# Access Compliance Report

## Public Rights-of-Way

Intersection ID: 18684	Main Street: LAMONT_DR	Cross Street: MURRAYHILL_RD	Location:	N
ADA ID: 839BB11AB8C0	Ramp Type: ParaDiag	Initial Pass/Fail: Pass	Overall Compliance: No	Severity Score: 5.25

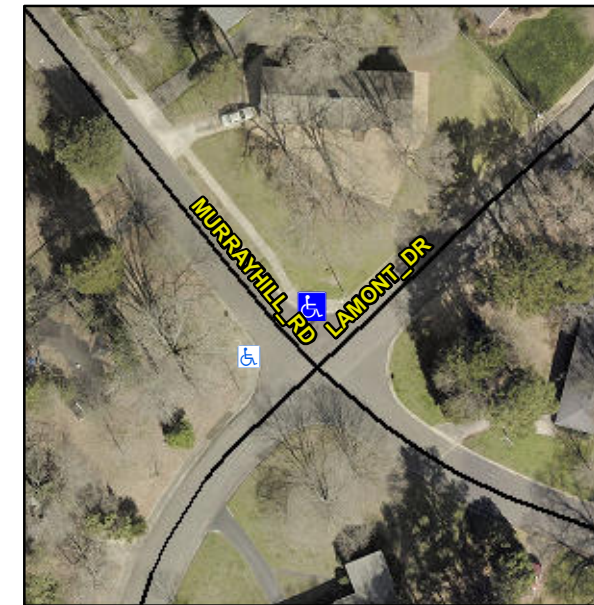
**R304.5.3, R304.2.2-Perp, R304.3.2-Para, R304.5.4**

Compliance	Description	Data	Compliance	Description	Data
N/A	Ramp Length LT (in)	48.0	N/A	Ramp Length RT (in)	74.0
Yes	Ramp Width LT (in)	71.0	Yes	Ramp Width RT (in)	50.0
Yes	Ramp Slope LT (%)	7.9	Yes	Ramp Slope RT (%)	7.1
No	Ramp XSlope LT (%)	3.7	Yes	Ramp XSlope RT (%)	1.0
Yes	Landing Length (in)	72.0	Yes	DWS Provided?	Yes
Yes	Landing Width (in)	48.0	Yes	DWS Contrast?	Yes
No	Landing Slope (%)	3.7	Yes	DWS Length (in)	24.0
No	Landing X Slope (%)	4.9	Yes	DWS Full Width?	Yes
N/A	Landing Curb? (Y/N)	No	Yes	DWS Offset (in)	1.0
N/A	Shared Landing?	No			
Yes	Gutter Ponding?	No	No	Gutter Slope (%)	15.5
Yes	Gutter Lip Ht (in)	0.0	No	Gutter X Slope (%)	5.6
N/A	Painted X Walk1?	No	N/A	Painted X Walk2?	No
	X Walk 1 Direction	To SW		X Walk 2 Direction	To SE
N/A	X Walk 1 Width (in)	N/A	N/A	X Walk 2 Width (in)	N/A
	X Walk 1 Slope (%)	9.0		X Walk 2 Slope (%)	3.6
	X Walk 1 X Slope (%)	1.9		X Walk 2 X Slope (%)	7.8
N/A	Ramp inside XWalk1?	N/A	N/A	Ramp inside XWalk2?	N/A

Road Slope (%)	6.1	N/A	Clear Space?	Yes
	Road X Slope (%)	9.1	N/A	Clear Space to XWalk (in)	N/A
Yes	Any Obstructions?	No	Yes	Storm Grate/Utility Hazard?	No
	Obstruction Type			Storm Grate/Utility Type	
		N/A			N/A
			Yes	Surface Condition? (G/P)	Good
			N/A	Curb Slope (%)	17.7

**Remove & Replace Curb Ramp With Two New Directional Ramps or Equivalent. Remove & Replace Gutter.**
